UNITED STATES OF AMERICA  
NUCLEAR REGULATORY COMMISSION

In the Matter of: )  
 )  
AREVA ENRICHMENT SERVICES, LLC ) Docket No. 70-7015-ML  
 )  
(Eagle Rock Enrichment Facility) )

APPLICANT'S RESPONSE TO PUBLICLY-AVAILABLE  
QUESTIONS ON THE SAFETY EVALUATION REPORT

FIGURE 1  
Topography Around EREF

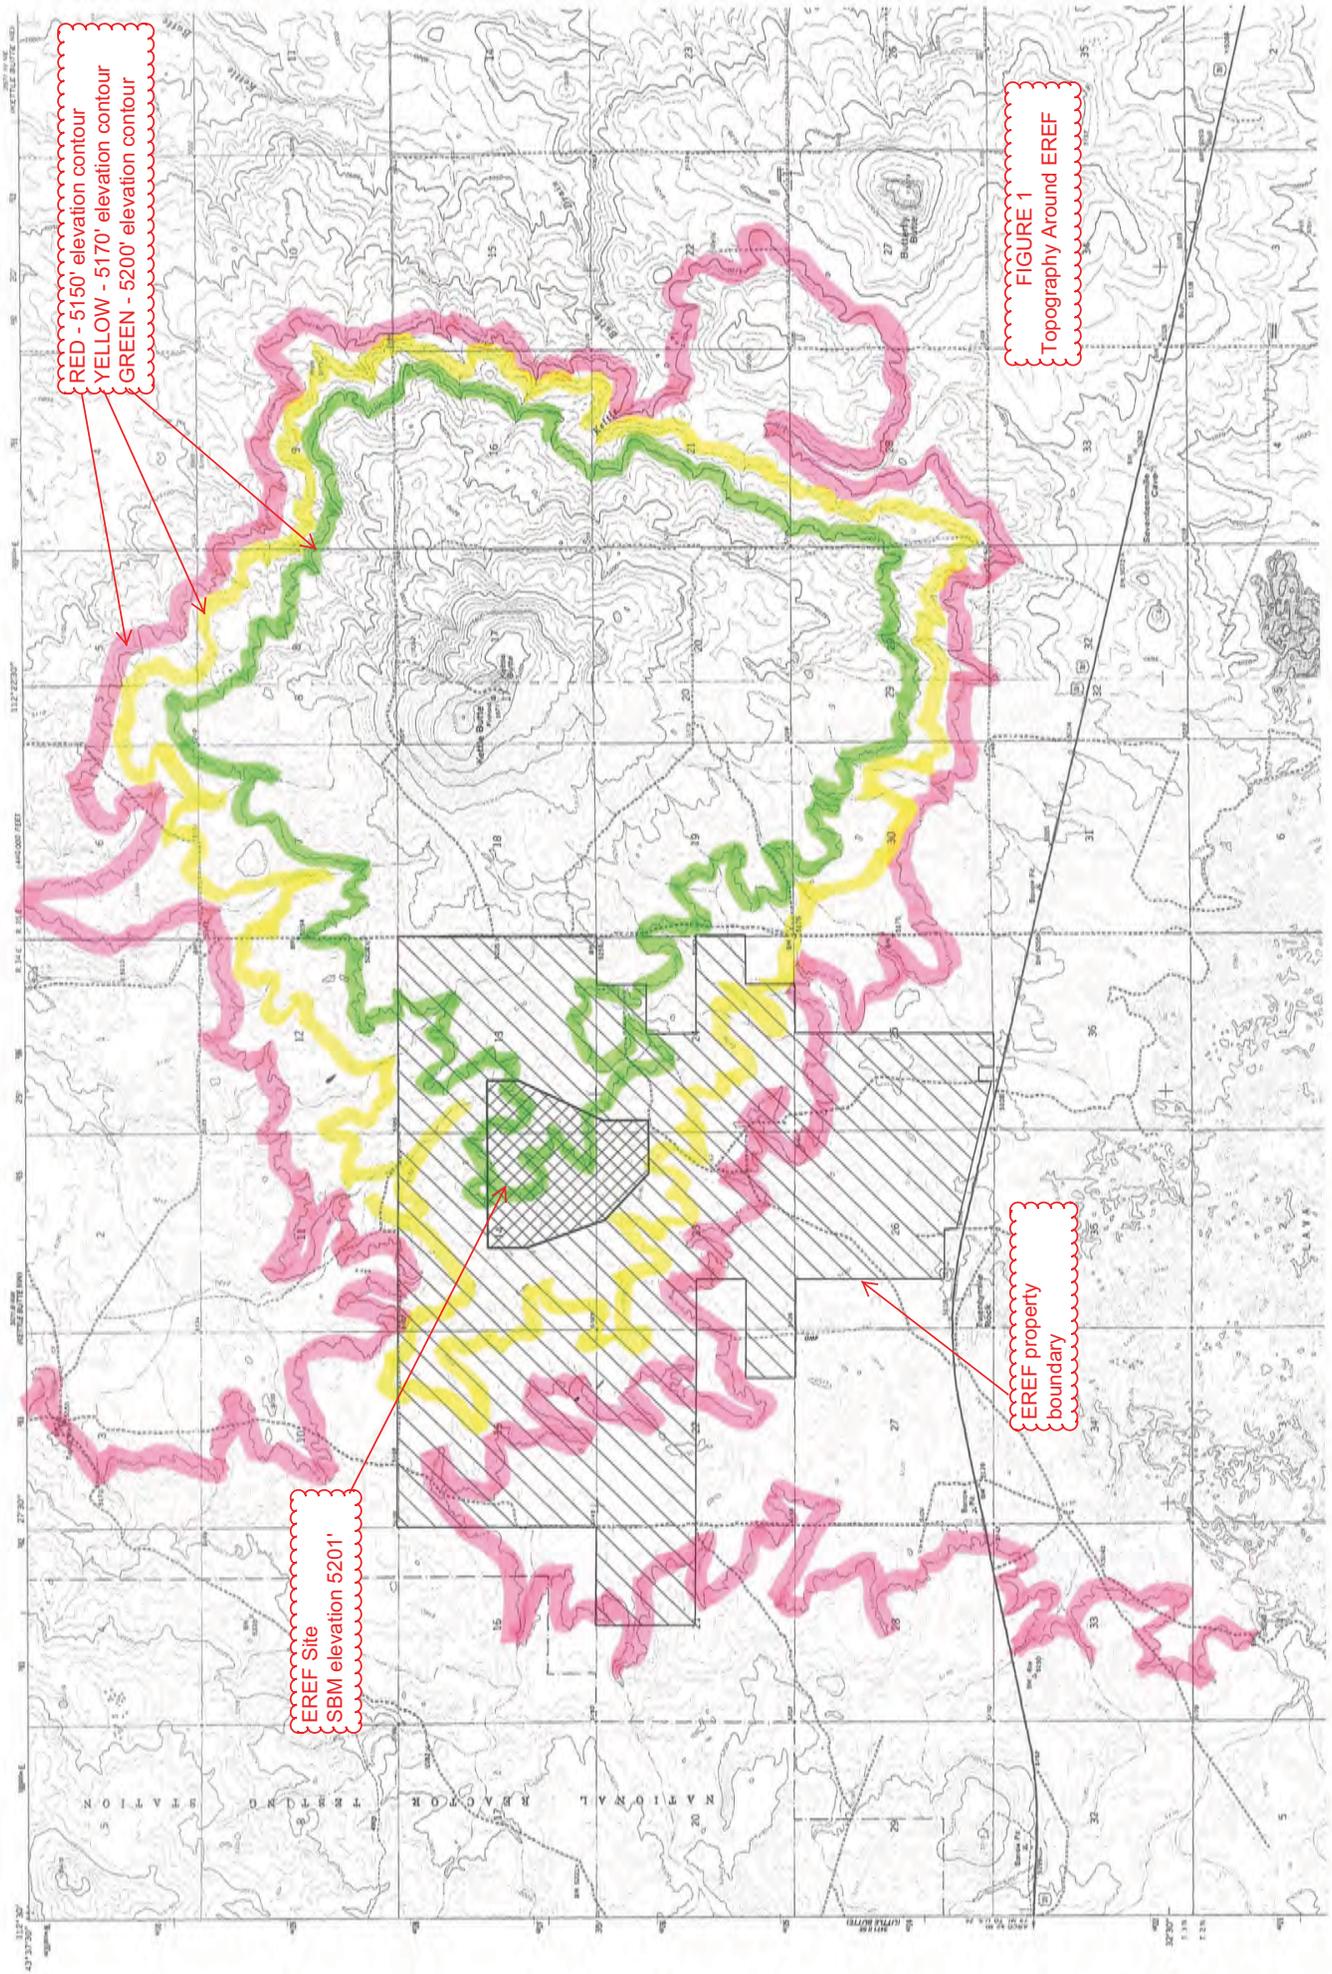
**(c) Discuss what preparations and procedures would be undertaken to minimize the potential release of hazardous materials if precursor**

**events, such as seismic activity or volcanic gas emissions, indicated an imminent eruption of basaltic lava that could threaten the EREF.**

Hackett et al. (2002, p 477 and 480) discuss the mitigation of basalt lava flow inundation and cite references on the subject. Most lava flows are expected to give at least a few weeks of advanced warning, depending on magma ascent rate and proximity of the eruptive vents, allowing time for mitigation measures. For the EREF, the most effective mitigation would be the construction of rock-rubble berms around critical portions of the facility (once it has been determined that lava is headed toward the facility). Such berms could be constructed of rock and soil excavated from the nearby land surface. Blong (1984, p. 193) reports numerous observations showing that lava flows with low yield strengths (*i.e.*, basaltic pahoehoe flows) can be diverted by resistant structures, if properly constructed. Additional mitigation measures would also include placing the facility in a safe mode and consolidating storage areas for material that could be released. Figure 1 (attached) also shows that the topography around the EREF is beneficial and provides substantial natural barriers to inundation at the site. With the

site elevation at 5201 feet, the terrain would divert lava flows of up to 8-10 m thick. The PVHA does not explicitly account for this topographical protection or take credit for its effects.
